SERVICE

BULLETIN

NUMBER 9

SUBJECT: Tail Surface Bracing

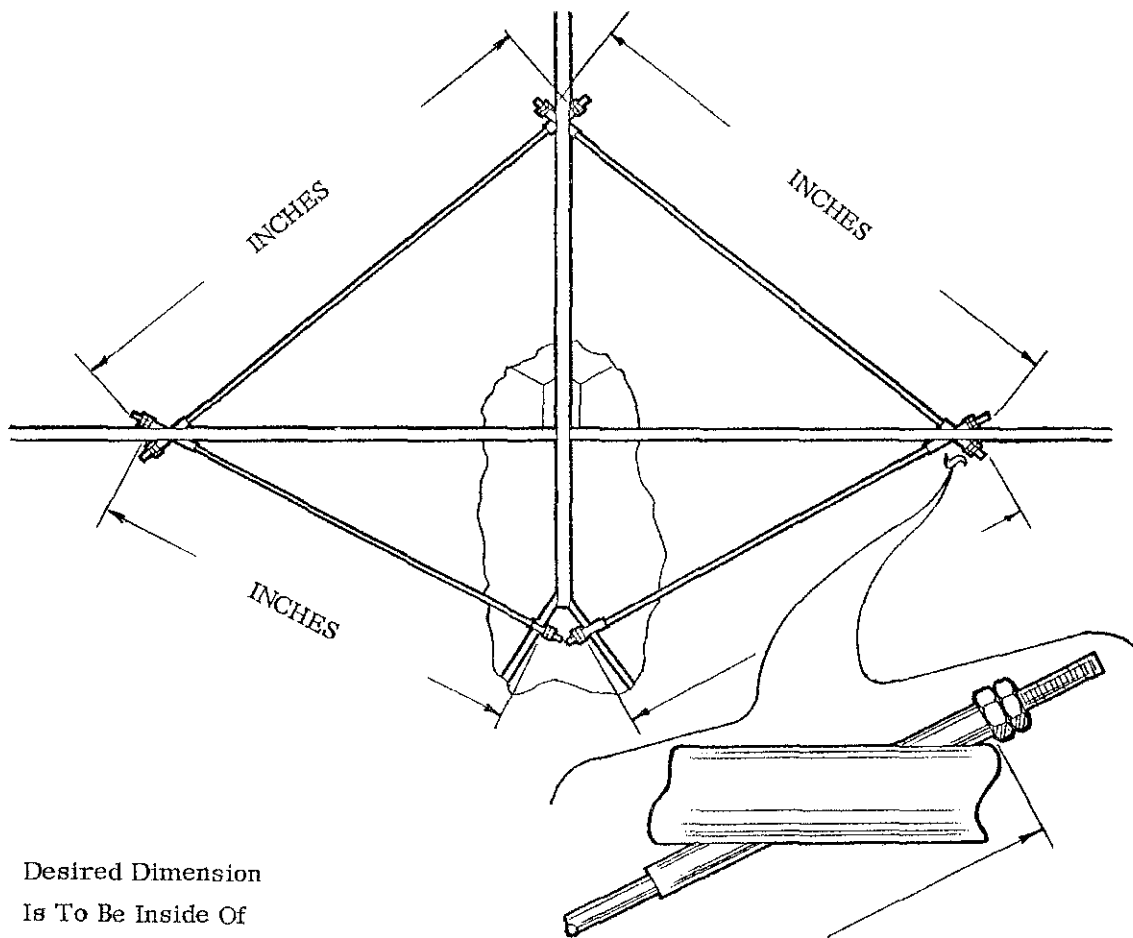
"Cubs" of Serial No. 1500 and up have this same size wire, but the end fittings are of a different design, making the bracing system more flexible and better able to absorb vibration. In order to accomplish the same purpose where the older type of fitting has been used, which carries the wires clear through the fin and stabilizer spars in bushing tubes, it will be necessary to replace the solid tie rods with a standard cable.

To facilitate this replacement in the field, fittings for the stranded cable are being made up at the factory such that the new flexible wires may be readily installed in the same fittings as used for the solid wires.

Note: Desired Dimension
Is To Be Inside Of
First Nut As Shown At
Right
